Bass Coast Amendment C152 – Wonthaggi North East PSP

Changes Report

November 2021

Figure 1 - Proposed Bushfire Plan (PSP Plan 8)

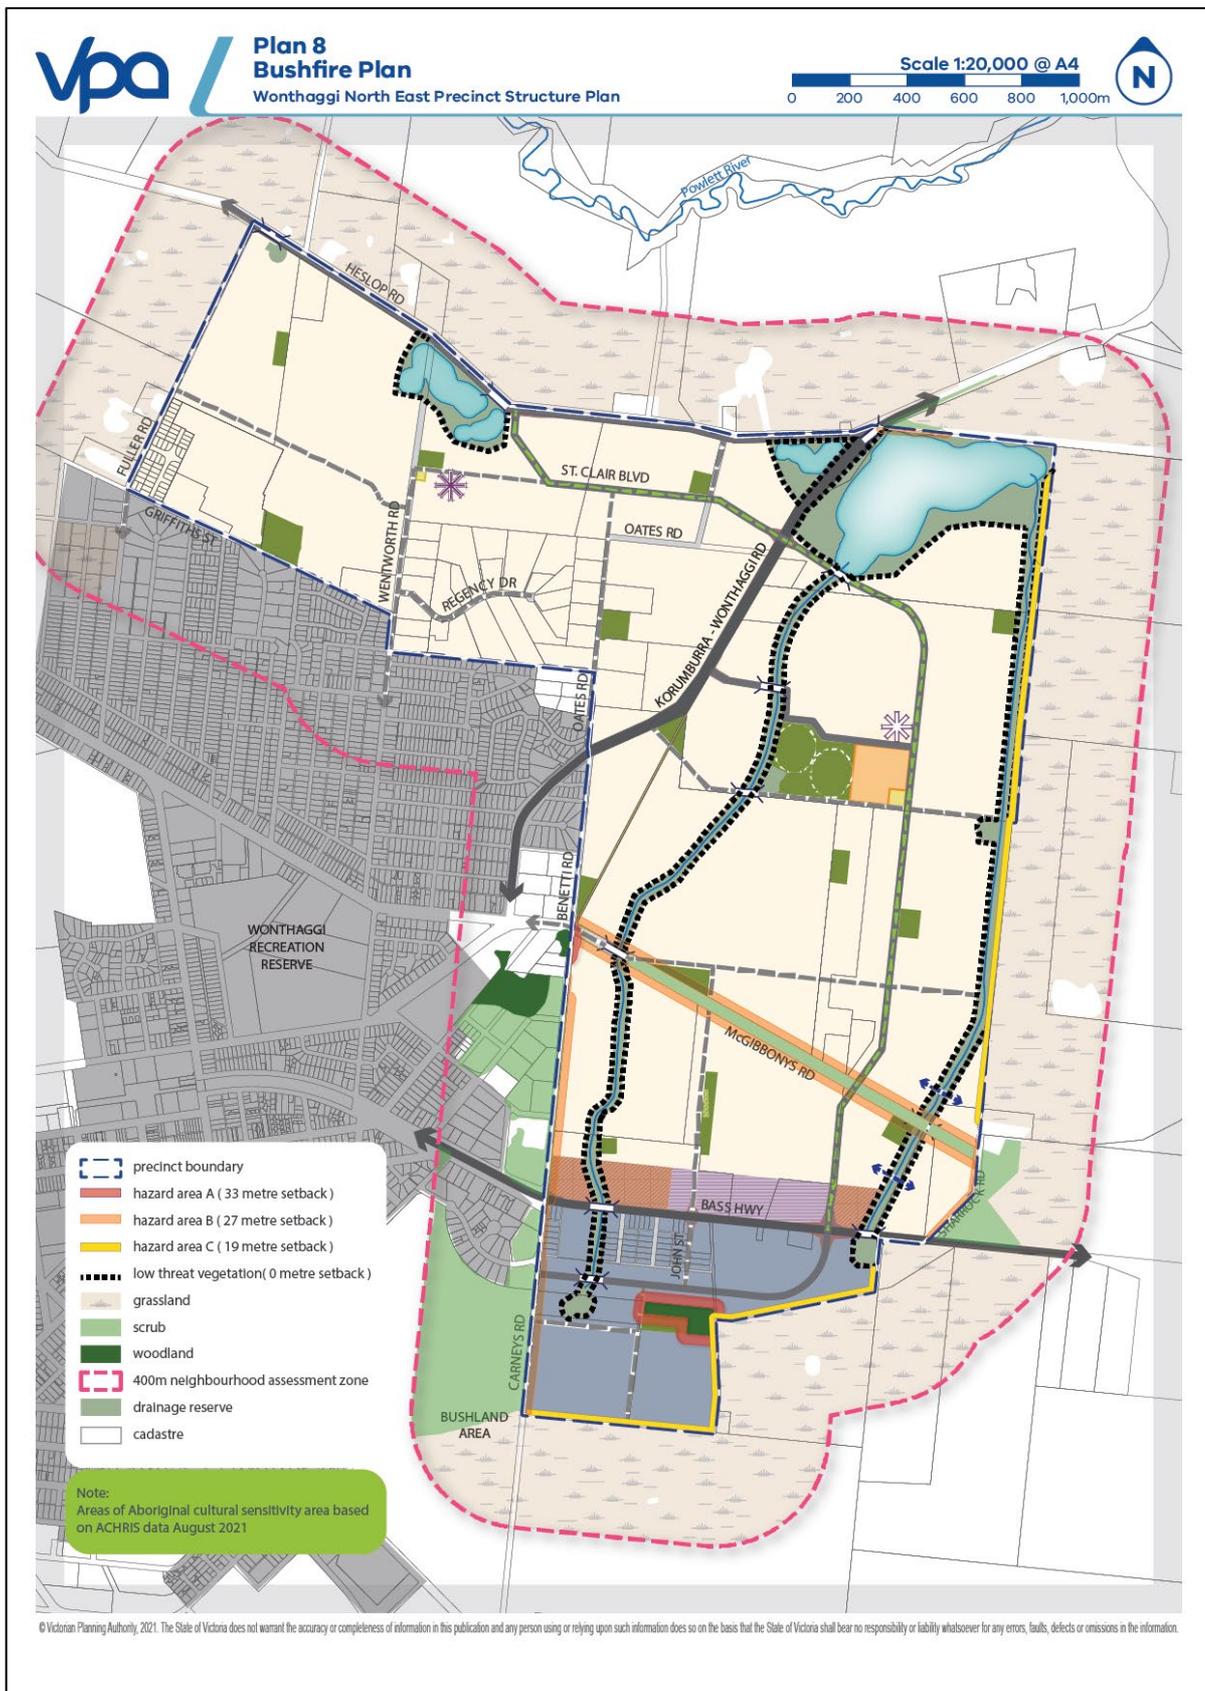
The addendum has informed revised proposed requirements, guidelines and plan changes in the November 2021 PSP. These changes are outlined below in the Requirement and Guideline excerpts and in Figure 1. In summary, these changes include:

- Updates to Bushfire Plan 8 to reflect the amended BAL-12.5 setbacks from waterways; and
- Amendments to various PSP requirements and guidelines to ensure landscaping provisions do not have the potential to extend identified bushfire hazard setbacks in Plan 8.

The below plan (Figure 1, PSP Plan 8), requirements and guidelines have been inserted into the November 2021 version of the PSP as the VPA’s approach in relation to managing bushfire hazard in the precinct.

NEW REQUIREMENTS	
R34	Vegetation within bushfire hazard areas shown on Plan 8 must be managed in way that does not exceed the nominated vegetation classification identified in the plan, unless otherwise agreed by the Responsible Authority and relevant fire authority.
R35	Where land is included in the Urban Growth Zone – Schedule 1, development adjoining bushfire hazards shown on Plan 8 must be setback in accordance with the distances specified on the plan unless otherwise agreed by the Responsible Authority and relevant fire authority.
R36	<p>Where land is included in the Urban Growth Zone – Schedule 1 and a setback from a bushfire hazard is required by Plan 8, unless otherwise agreed by the Responsible Authority and relevant fire authority, vegetation within the setback must be managed in accordance with the following standard:</p> <ul style="list-style-type: none"> • Grass must be short cropped and maintained during the declared fire danger period. • All leaves and vegetation debris must be removed at regular intervals during the declared fire danger period. • Within 10 metres of a building, flammable objects must not be located close to the vulnerable parts of the building. • Plants greater than 10 centimetres in height must not be placed within 3m of a window or glass feature of the building. • Shrubs must not be located under the canopy of trees. • Individual and clumps of shrubs must not exceed 5 sq. metres in area and must be separated by at least 5 metres. • Trees must not overhang or touch any elements of the building. • The canopy of trees must be separated by at least 5 metres. • There must be a clearance of at least 2 metres between the lowest tree branches and ground level.

NEW GUIDELINES	
G42	All vegetation outside of a bushfire hazard area shown on Plan 8 should be managed to ensure a low risk of bushfire.
G43	Subdivision adjoining Bushfire Hazard Areas A, B & C should include a perimeter road unless otherwise agreed by the Responsible Authority and relevant fire authority.
G44	Subdivision should include a network of streets that provide multiple evacuation routes away from bushfire risks and areas of bushfire hazard.
G45	Where a setback is required from a bushfire hazard, the setback should be provided on public land where practical.
G46	All fencing adjoining Bushfire Hazard areas 1, 2 & 3 shown on Map 1 should be made from non-combustible materials.
G47	Landscape design and plant selection in open spaces, including waterways and drainage corridors, should not increase bushfire risk beyond the categorisation shown in Plan 8.
G48	Interim bushfire hazards should be identified and risks appropriately mitigated during development.

Figure 5 - Excerpt of Plan from Closing Submission showing realigned eastern waterway and Mixed Use rezoning

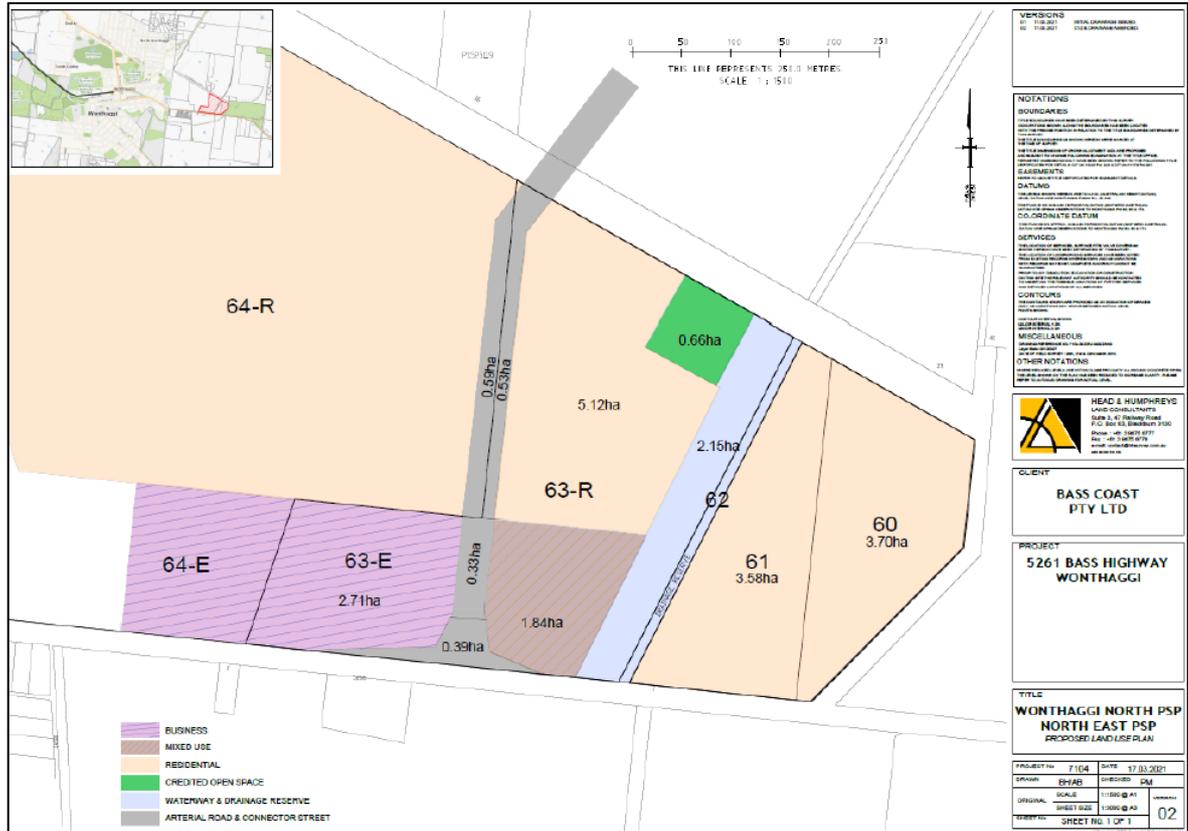
- *the depth of the C2Z land be 90 metres;*
- *the MUZ be extended eastwards, as identified below; and*
- *it will support the realignment of the drainage corridor, subject to approval from DELWP and any investigations as part of the further drainage work undertaken as part of Tranche 2. (The VPA and Council note that the drainage corridor is Crown land and that shifting the drainage will impact on the existing culvert location and shorten the pipe south of the culvert.)*

The above position is illustrated in the following plan:

Figure 6 - Future Urban Structure Comparison for Submitter 10 Changes

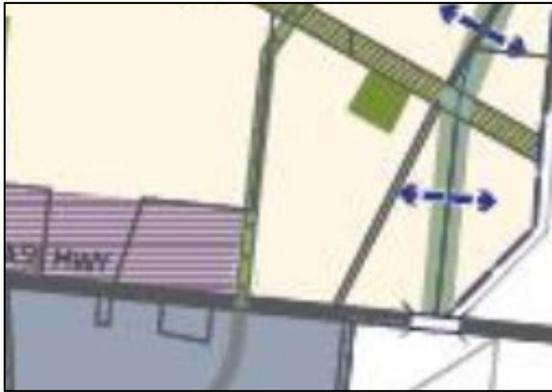
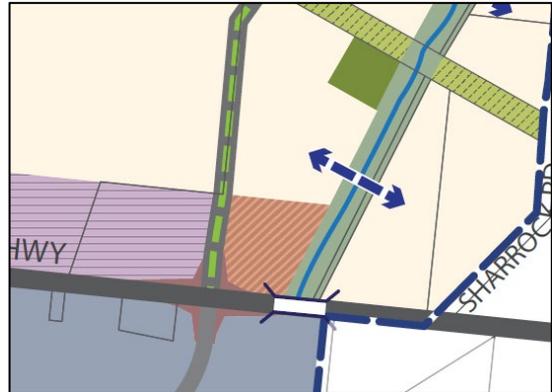
However, it is noted that the statement made in the VPA and Council’s closing submission relating to the depth of the Commercial 2 Zone (CZ2) land being 90m is erroneous, and the depth of the CZ2 land in the November 2021 PSP has not been changed from what’s shown in the exhibited version. Submitter 10 requested the land to the east of the boulevard be rezoned to commercial (submission item 10.07). The VPA and Bass Coast Council did not support an over-provision of CZ2 land in the precinct. Therefore, in order to accommodate this land to the east of the boulevard, it was proposed to reduce the existing extent of the submitter’s CZ2 land to 90 metres in order to ensure there was no net increase of commercial land.

However, during the Tranche 1 hearing, Submitter 10 changed their position and requested the land to the east of the intersection be rezoned to MUZ instead of the CZ2. If the 90m depth of the CZ2 land were to be retained, this would result in a net loss of CZ2 land, contradicting the recommendations of the *Commercial and Industrial Land Assessment* (prepared by Urban Enterprise, 2017) that recommended 8 hectares of CZ2 land be provided within the PSP. Therefore, when making these changes, the depth of the CZ2 land has been retained. It is also noted that the above plan that was prepared by Submitter 10 and included in the VPA and Council’s closing submission did show the Commercial land at a depth of 90m.

The exhibited and November 2021 PSP versions demonstrating the implemented changes are shown in Figure 6.

Figure 7 - Cross Section 15

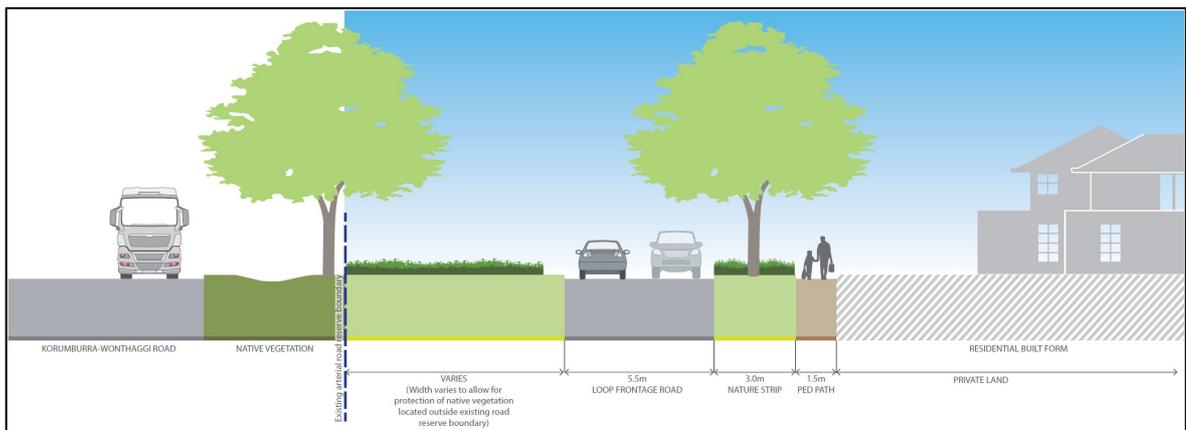
A new cross section showing services roads on both sides should be added to the PSP to apply to the Korumburra-Wonthaggi Road interface with abutting residential areas.

This cross section has been added to the November 2021 PSP and is identified as Cross Section 15. The cross section depicts Korumburra-Wonthaggi Road and the service road interface it will have with residential areas. Plan 9 (Road Network) has also been updated to reference the new cross section. An excerpt of the cross section is provided in Figure 7. It is noted that DoT were consulted on the cross-section prior to its inclusion into the November 2021 PSP and provided support for its design.

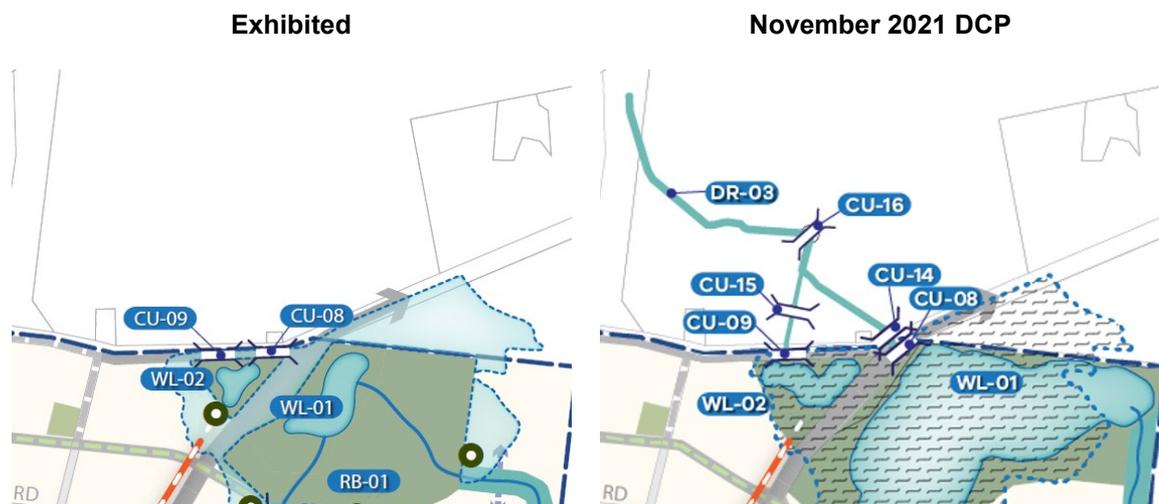
The revised *Drainage Strategy* (Engeny, 2021) indicates an increase in the peak 100-year AEP flows onto the property outside the PSP area at 465 Heslop Road, Wonthaggi and proposes to convey flows through the property by formalising existing drainage channel infrastructure to the Powlett River.

Alluvium Consulting prepared the functional design and cost for the main outfall channel infrastructure.

Removal of CU-011

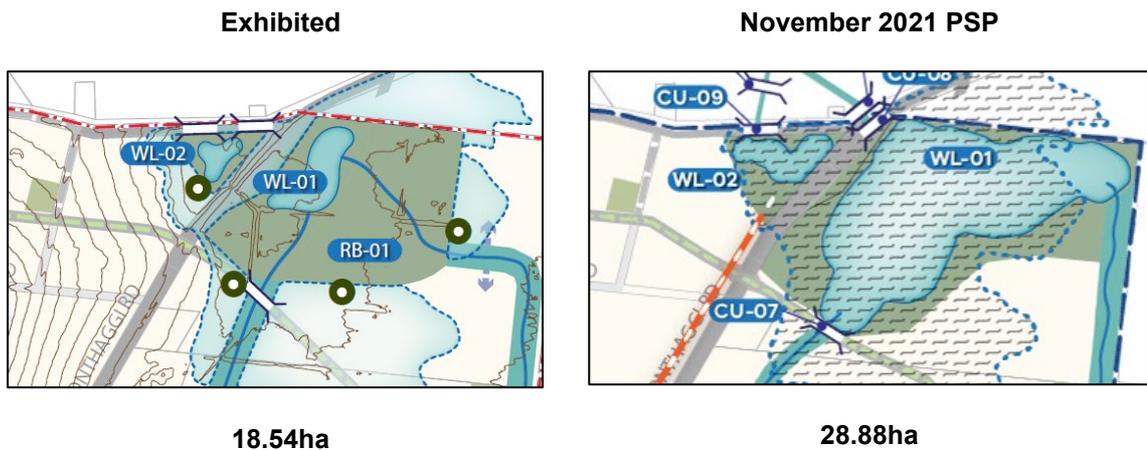
CU-011 has been removed from the PSP as Alluvium has not identified this asset as part of the functional drainage layout.

Figure 9 - Proposed boulevard connector and intersection alignment, accounting for WL-01 footprint

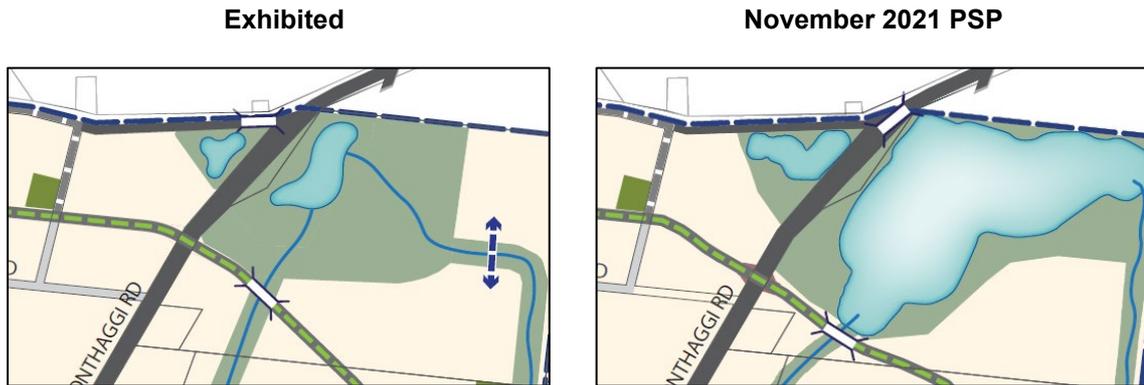
As the footprint of WL-01 had been modified, the boulevard connector road and Korumburra-Wonthaggi Road/boulevard connector intersection has been shifted to avoid conflict with the new wetland footprint (See Figure 9).

Figure 10 - Proposed new boulevard connector and intersection location

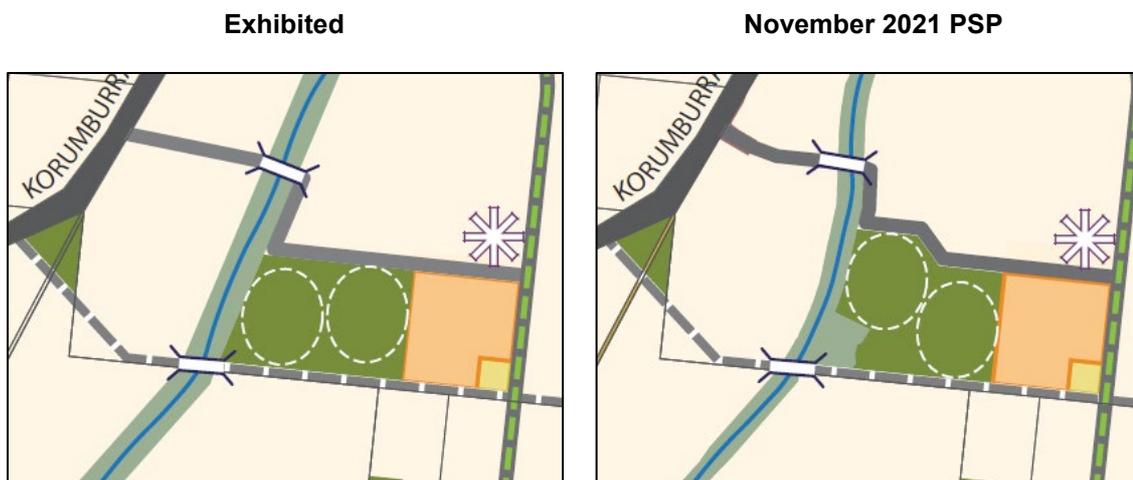
Alluvium have identified the south-western corner of the active recreation reserve as the most appropriate location for a sedimentation basin. Consequently the active recreation reserve footprint and adjacent connector street has been modified to accommodate the new drainage asset (See Figure 10). Concept 2, the “Village Hub Concept Plan” has also been updated accordingly.

3.2.0 IN-01 consideration of water main

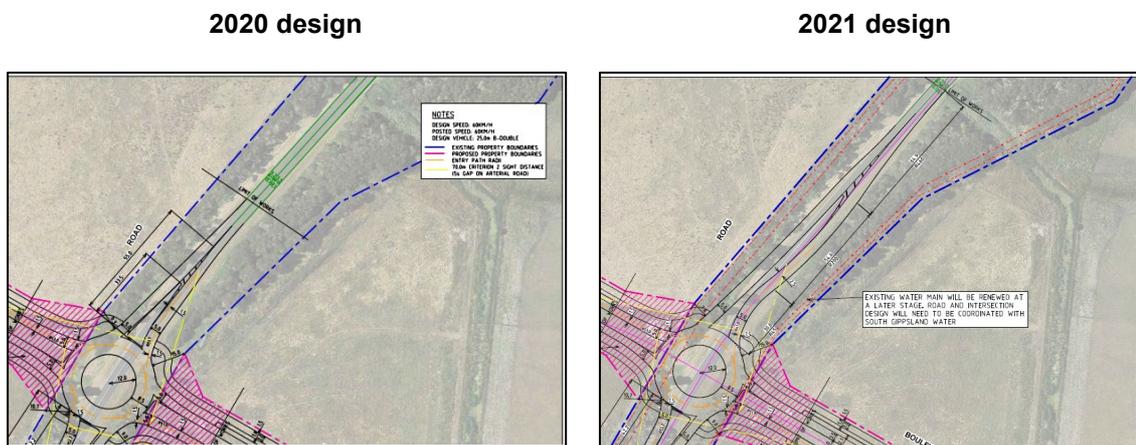
South Gippsland Water advised that there is an existing water main located on the southern side of Heslop Road that crosses Fuller Road on the southern side of IN-01. To avoid relocating the existing South Gippsland Water asset within the Fuller Road Road reserve, the future Fuller Road carriageway may need to be realigned east of the existing road reserve. This does not result in a PSP change as more detailed investigations will be undertaken at the functional design stage, however a note has been included in the concept drawing for IN-01 to investigate further.

Figure 11 - Excerpts of Plans 2 and 12 showing gas pipeline and relevant buffer distances

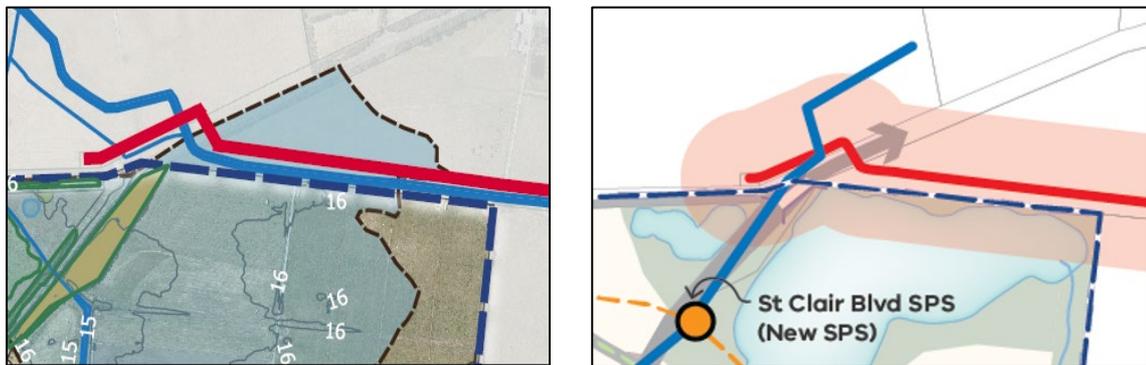
Plan 2 – Precinct Features and Plan 12 – Utilities have been updated to depict the transmission pressure gas pipeline, with Plan 12 also depicting the measurement length identified in the SMS (143m). The identification of the measurement length is important for the implementation of objectives, guidelines and provisions in the PSP and ordinance to appropriately manage safety with respect to the pipeline.

Excerpts of Plans 2 and 12 showing the pipeline and relevant buffer distances are shown below.

Figure 12 - LP-12 Redistribution

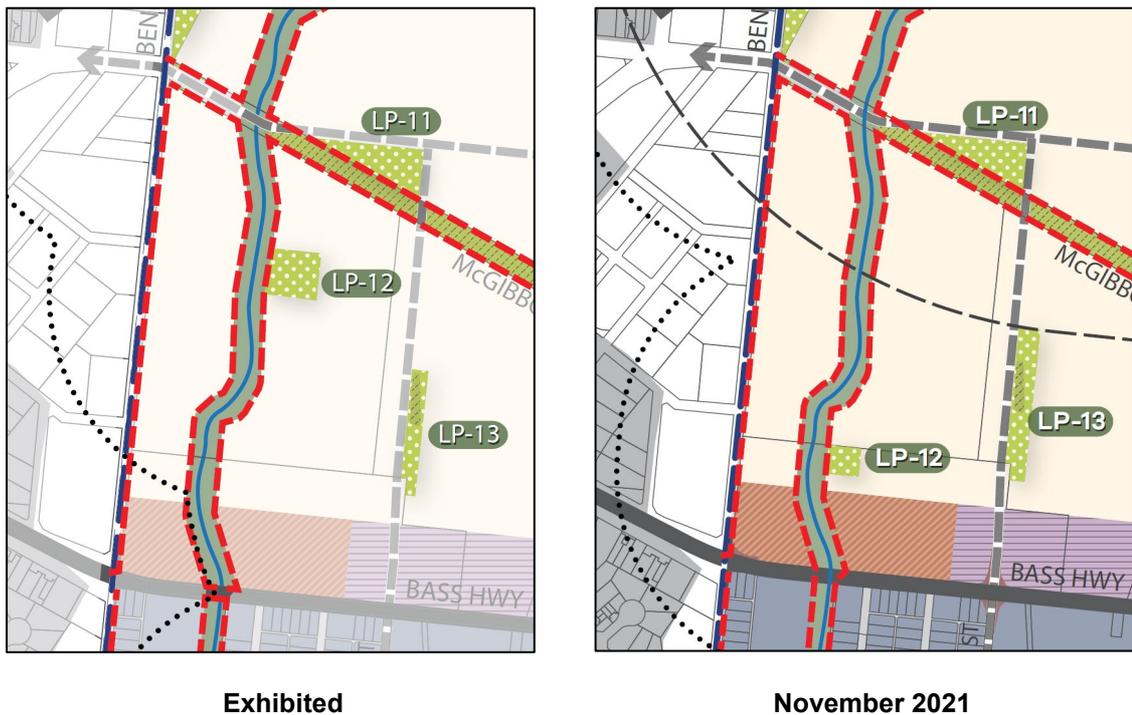
LP-12 (0.83ha local park) was redistributed from PSP Property 65, with LP-12 now consisting of a 0.34ha park in PSP Property ID 66-R, and with LP-13 on PSP Property 64-R increasing from 0.51ha to 1ha (extending further north). This change was made in response to a planning permit for subdivision that is approved on Property 65 which did not include a local park. This was raised by submitter 31 (submission was located late and circulated as part of re-notification on November 2021). Therefore, in order to ensure there was no net loss of open space in the area, the area of the park was redistributed across adjoining properties to preserve the walkable catchment of local parks within the PSP. The changes are reflected in the November 2021 PSP, excerpted and compared with the exhibited version identified in Figure 12. The change also results to amendments to the Land Use Budget for PSP Properties 64-R, 65 and 66-R.

Figure 13 - PSP Boundary Amendment

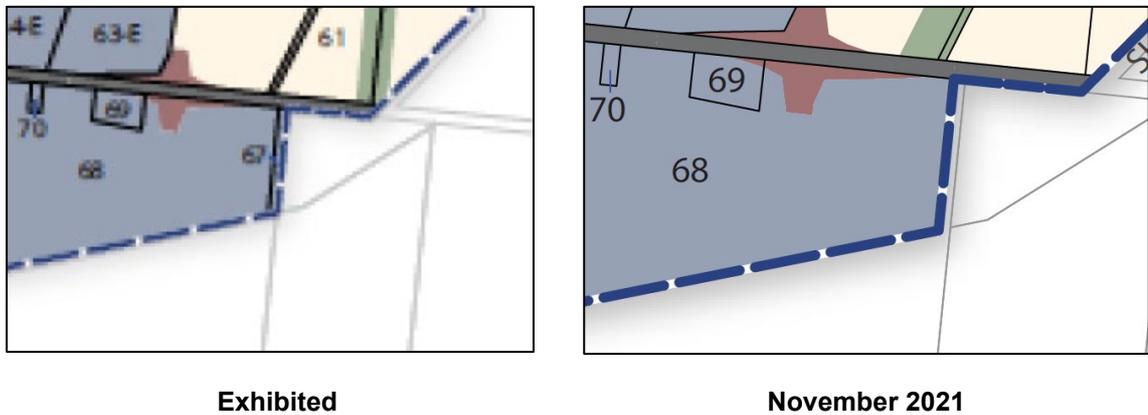
The PSP Boundary has been slightly amended to exclude PSP Property ID 67, which was mistakenly included within the boundary of the PSP. Property 67 was a small slither of land that formed part of a larger property to the south of the precinct (see Figure 13). In order to maintain continuity between the exhibited and November

2021 versions of the PSP and DCP, the numbering of all succeeding PSP properties have not changed. The property has been removed from the Land Use Budget table, and the boundary change is reflected in all PSP and DCP plans.
